## SERVICE BULLETIN

**APPLICABILITY:** 2020-24MY Legacy 2.4L  
 2020-24MY Outback 2.4L  
 2019-24MY Ascent  
 2022-24MY WRX  
 2022-25MY Outback Wilderness

**NUMBER:** 16-150-24R

**SUBJECT:** Transmission Control Module (TCM) / Software Enhancement

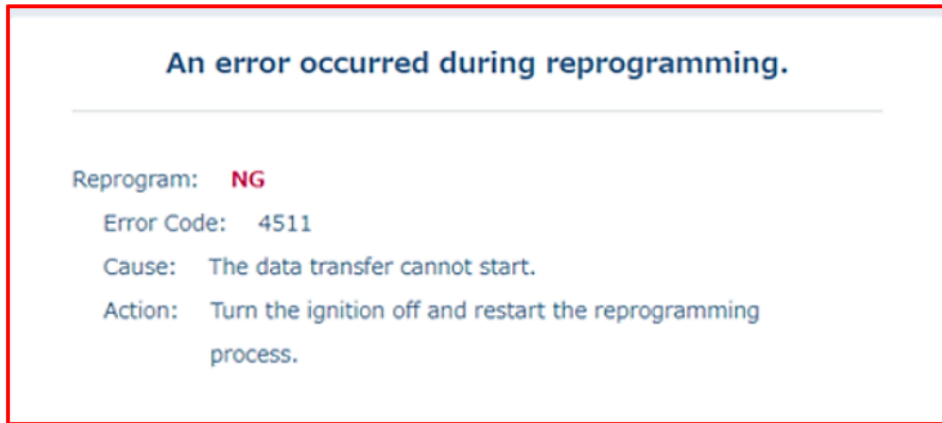
After clicking the line, does the detail text box display stating “The TCM cannot be reprogrammed, replace the TCM with latest superseded part”?

This TCM cannot be reprogrammed, replace TCM with the latest superseded part.

**YES:** The TCM is **NOT** suitable for reprogramming. Continue to Step 3.

**NO:** The TCM is suitable for reprogramming. Perform the SSM5-R reprogramming procedure.

**STEP 3:** When the TCM is **NOT** suitable for reprogramming one of the following “Dummy PFC files” will be displayed along with an added instruction detail. Proceed to Step 4.
